EEG-68
DOE/AL/58309-68

EVALUATION OF THE WIPP PROJECT'S COMPLIANCE WITH THE EPA RADIATION PROTECTION STANDARDS FOR DISPOSAL OF TRANSURANIC WASTE

March 1998

Figure 1. Lease grade potash ore[2] and oil and gas wells.[3]

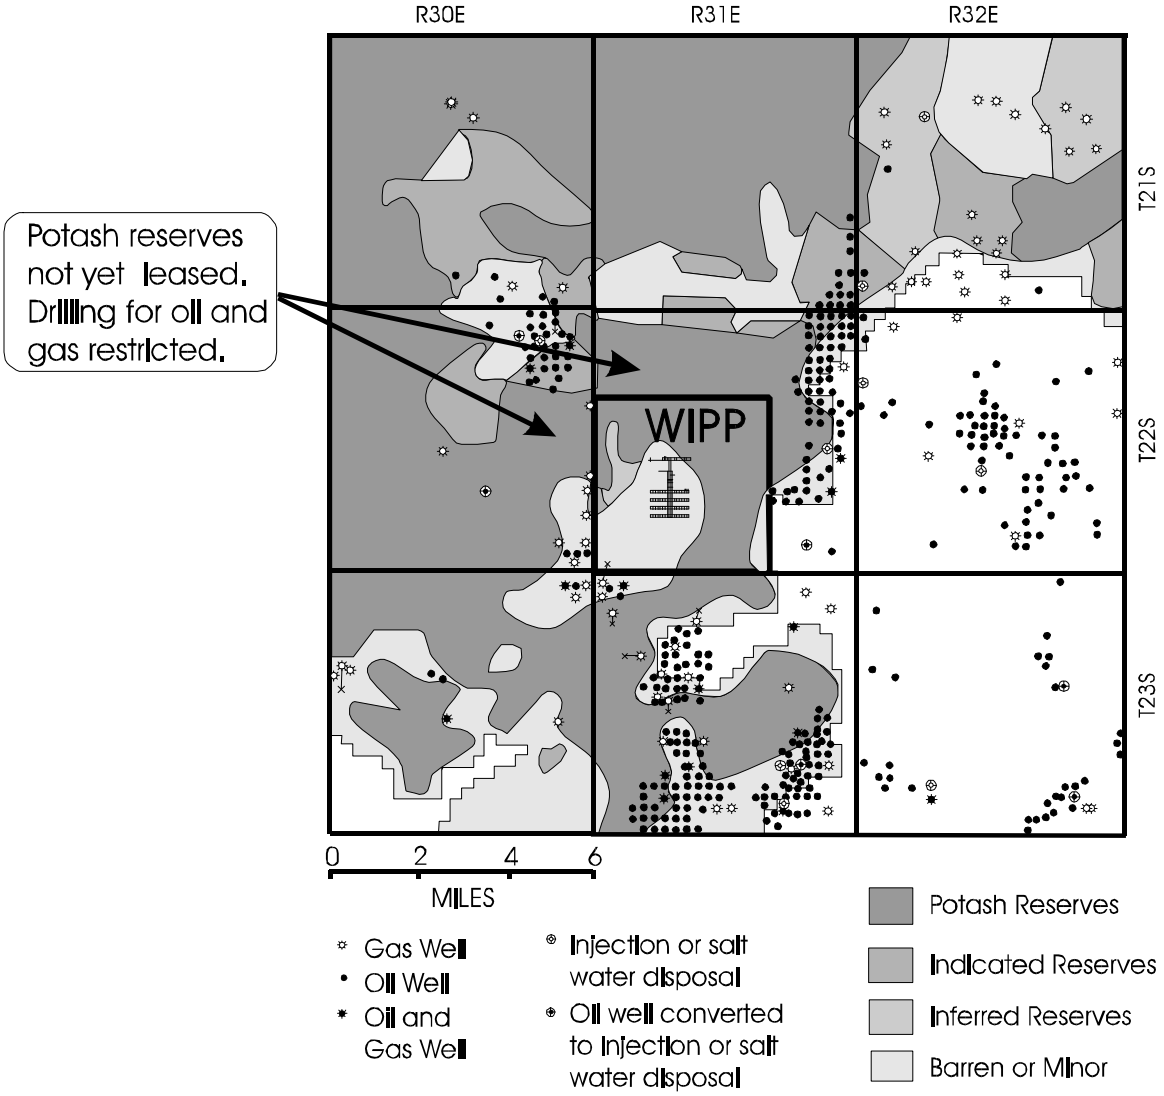
For illustrative purposes, Figure 1 identifies one area of known potash reserves adjacent to the northwest boundary of the WIPP Site. Figure 2 indicates that these potash reserves have not been leased. Potash operators are allowed to hold, directly or indirectly, no more than 51,200 acres in potash permits and leases in a state (43 CFR 3530.3). An operator may not hold all the potash leases he intends to develop (Ref.4, p. 11).

Figure 3. Minable potash.

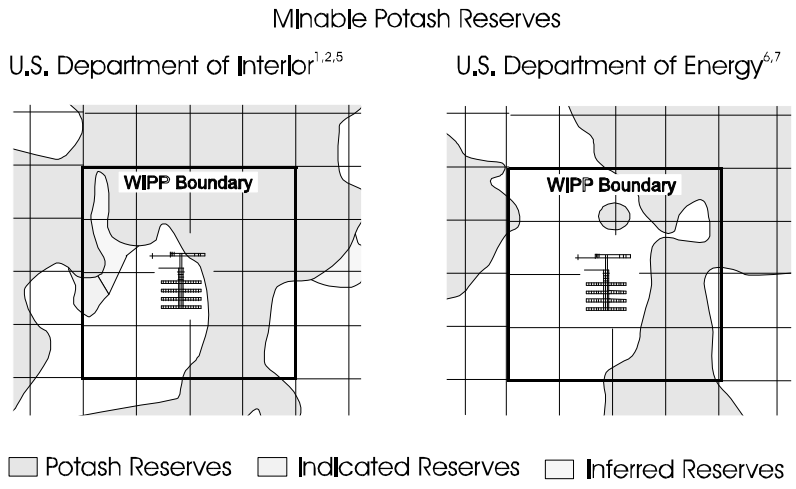
Figure 3 shows the different estimates by DOE and DOI of the extent of minable potash within the WIPP site.

Figure 4. Potash leases within the Delaware Basin and minable potash not yet leased.

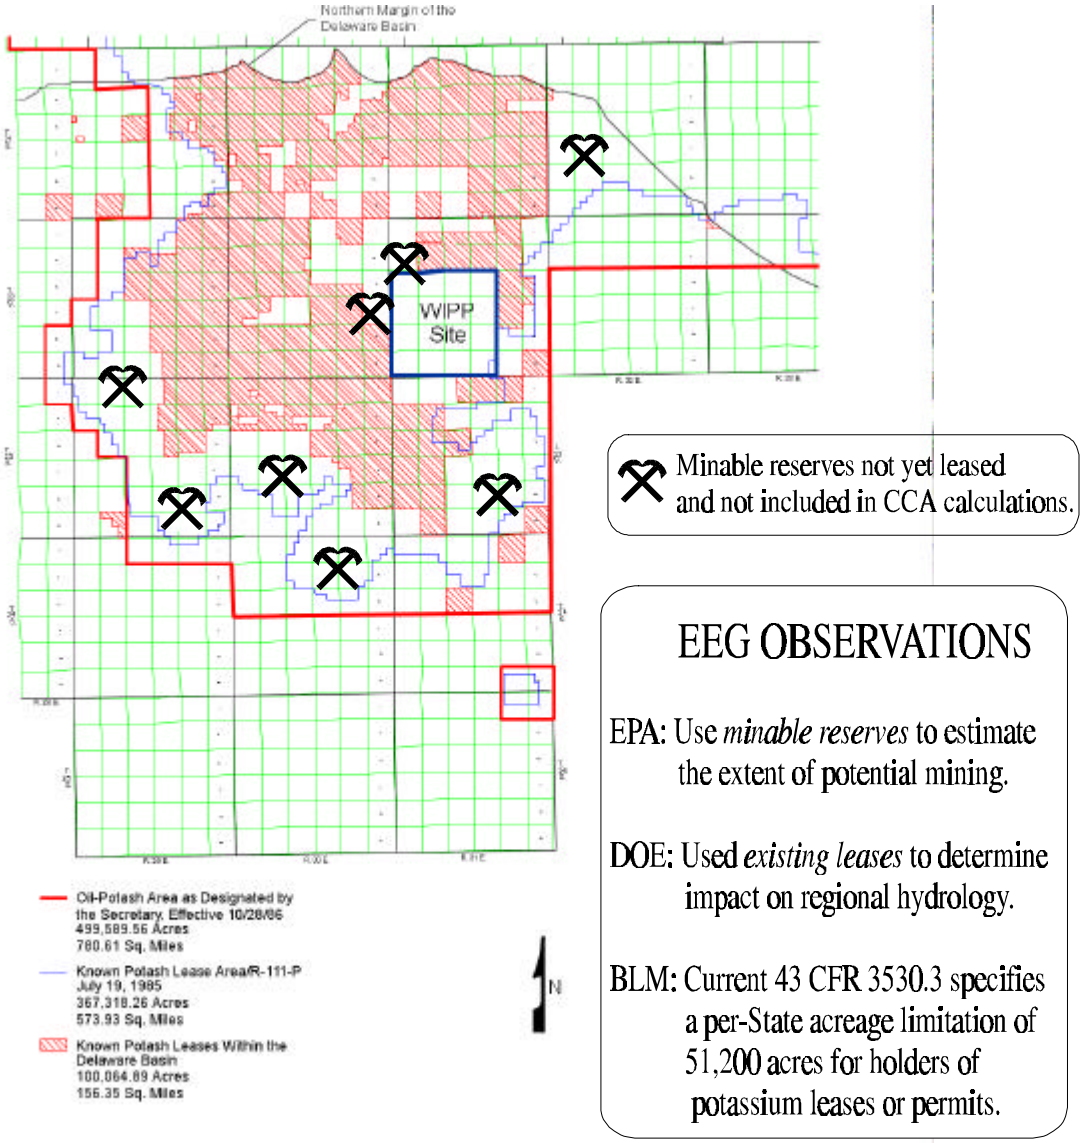
As shown in Figure 4, the CCA does not include the impact of potash mining in unleased areas which will also affect the regional hydrology. 40 CFR Part 194.32 states:

Figure 2: Cumulative Net Brine in and outflow at Repository, FEP S-1 Analysis
From Vaughn et al, 1996.

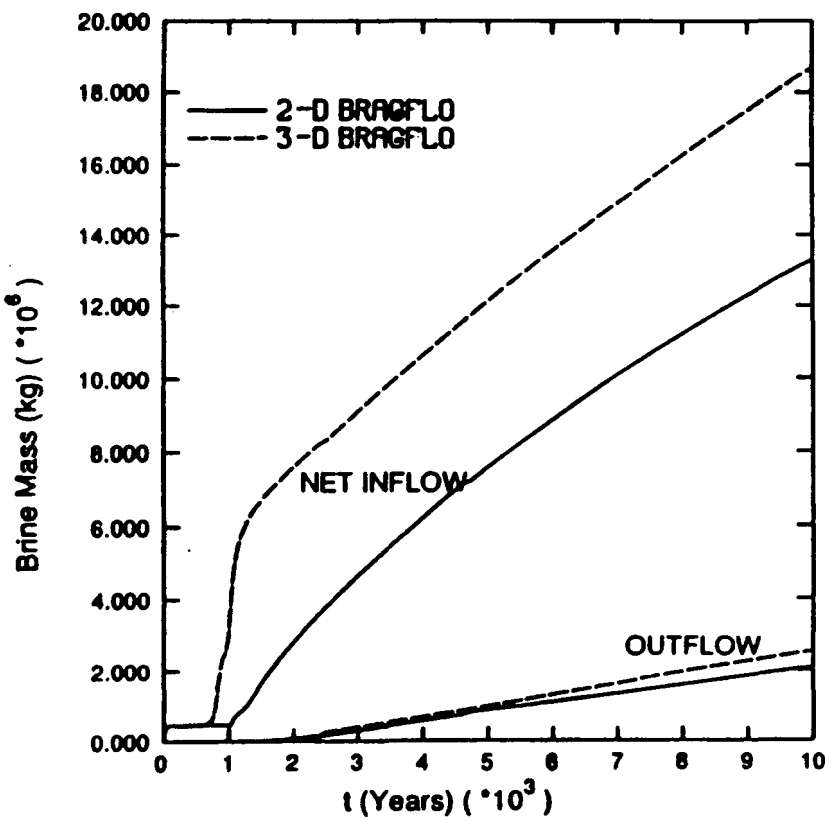
Figure 2 depicts the calculated brine inflow and outflow rates. The figure shows a large difference in calculated inflows of the two models during the period of 700 to 1,000 years. Figure 3 reinforces the perception that the brine inflow in the 3-D model is large. As shown in Figure 3, during the 700 to 1,000 years period the 3-D model shows a decrease in gas saturation of 0.05. Our concern is that if the brine inflow calculated in the 3-D model persists for thousands of years then the 2-D model calculations significantly under-predict repository saturation at high pressures.

Figure 4: Three dimensional scatter plots for volume of brine reaching the surface due to direct brine release for a drilling intrusion into the lower panel.
From Helton, 1996.

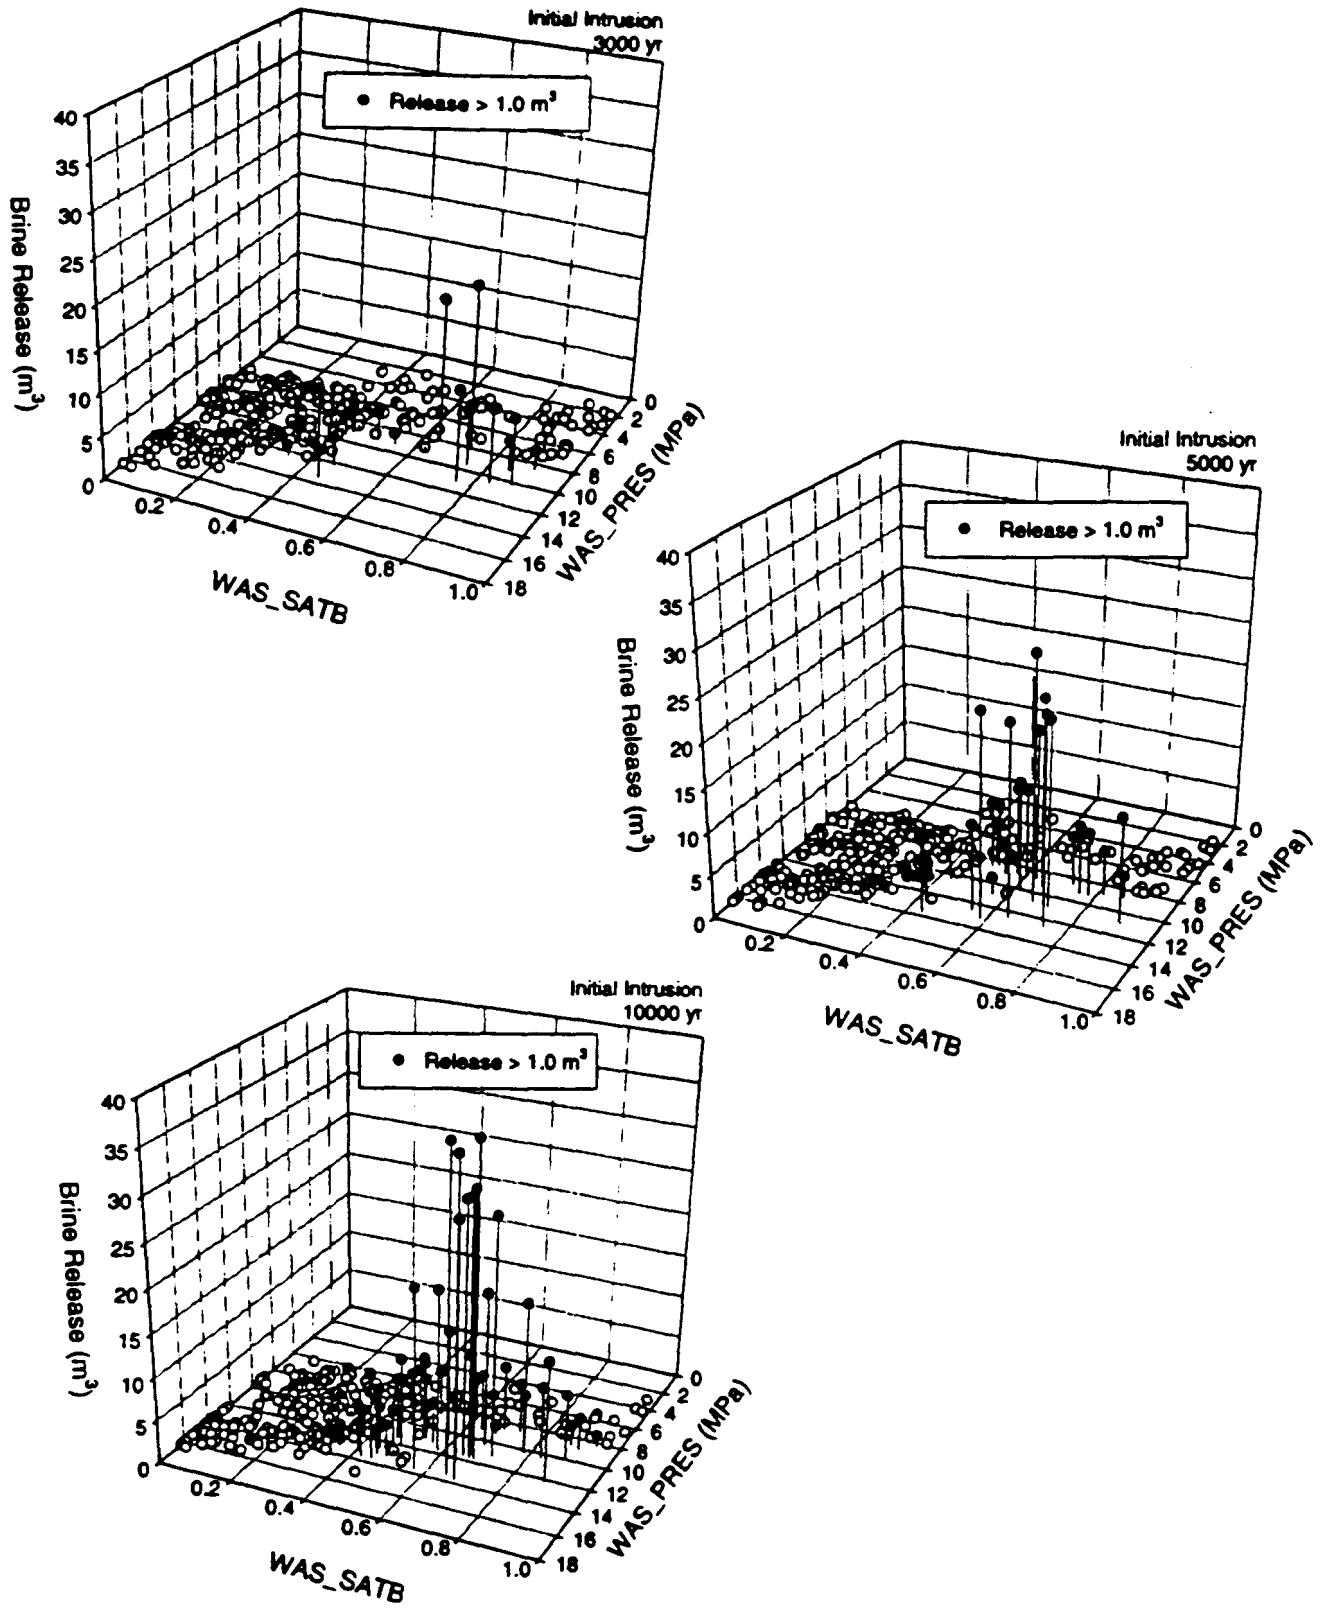
Greater saturations could lead to much larger direct brine release calculations. Figure 4 (Figure 5.1.5 of *Helton)* is the basis of this contention. Figure 4 depicts the relationship of calculated direct brine releases to repository conditions at three separate times. The average repository brine saturation and repository pressure are plotted for each vector on the horizontal plane. A vertical line connects the plane to a small circle at the level of the vertical axis corresponding to the volume of brine calculated to reach the surface. Calculated releases greater than one cubic meter are highlighted using a filled circle.
